SCALE:
1" = 10'
SHEET OF SHEETS
13 OF 73

BUSH STREET TRAFFIC SIGNAL UPGRADE
BUSH ST AND BRODERICK ST

SPECIFICATION NO.
0286J
DRAWING NO.
E-4.0
FILE NO.
78205
REV. NO.
2

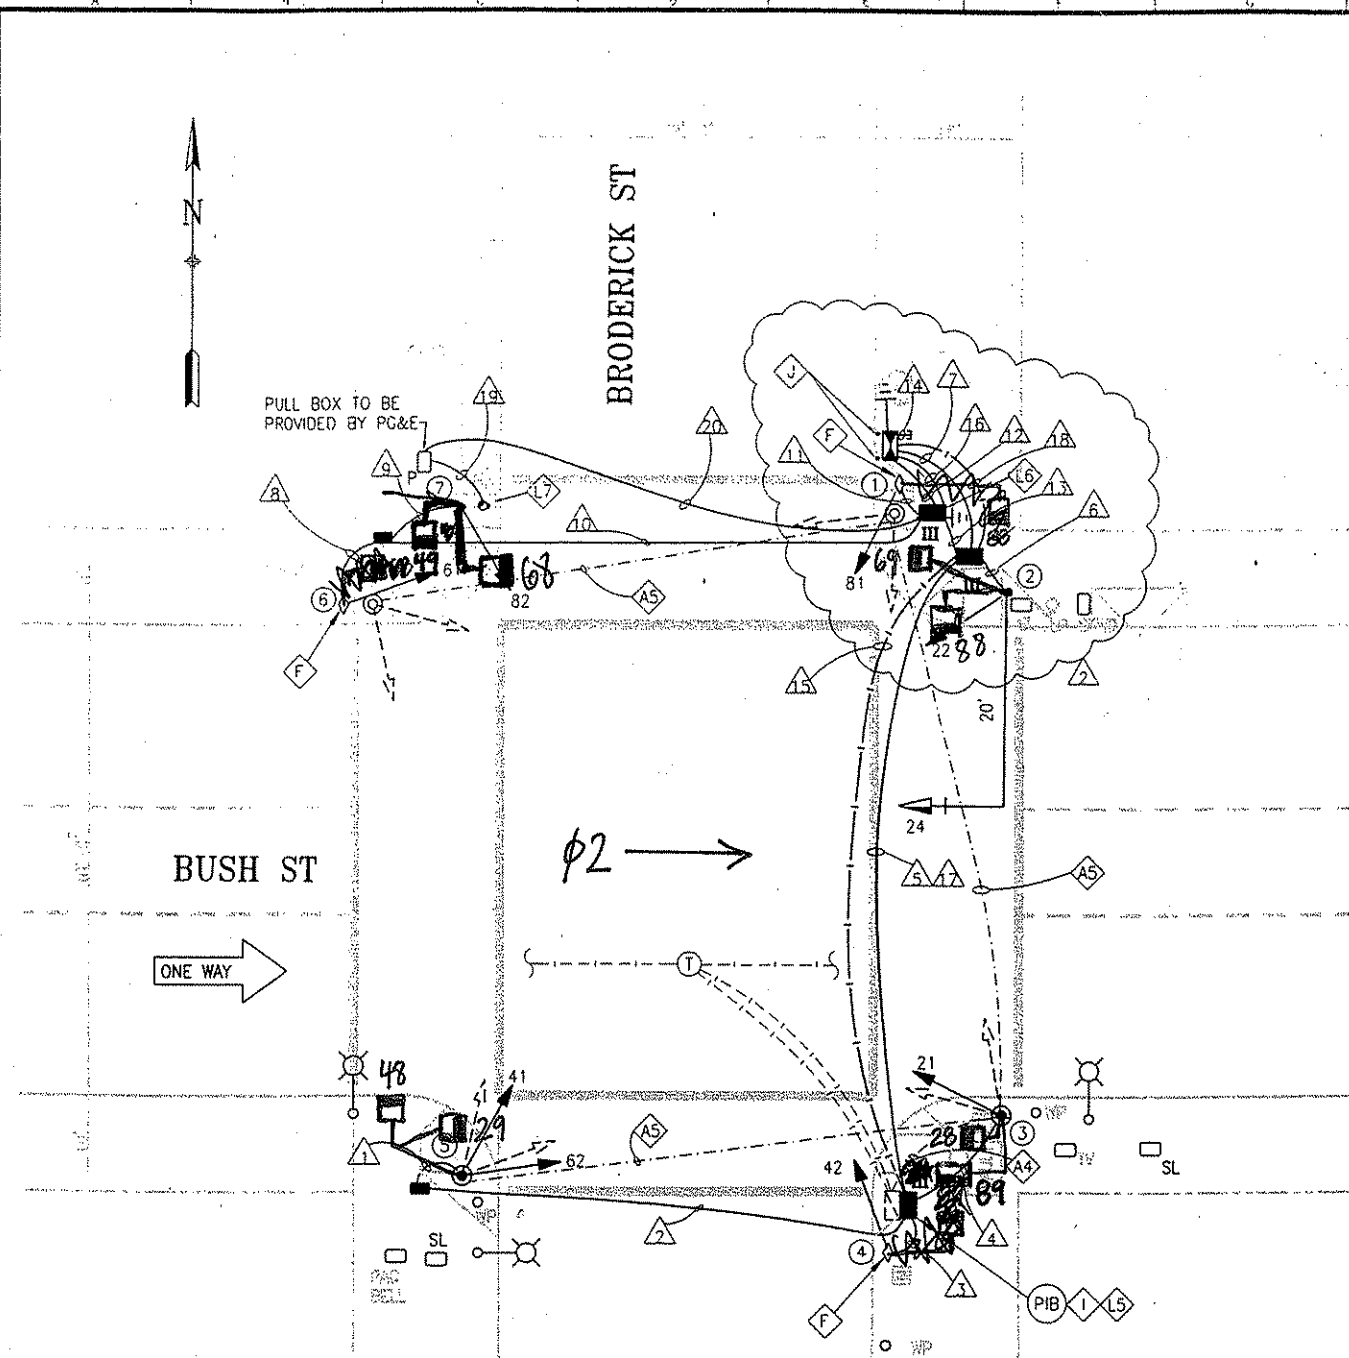
● = Conceptual Design
● = Walk Through Comments (11-10-04)

REFERENCE INFORMATION & FILE NO. OF SURVEYS			
NO.	DATE	DESCRIPTION	BY APP.
12/02	PCO-3: VARIOUS	TP	BC
10/02	PCO-1: NEW SERVICE	TP	BC
TABLE OF REVISIONS			
CHECK WITH TRACING TO SEE IF YOU HAVE LATEST REVISION
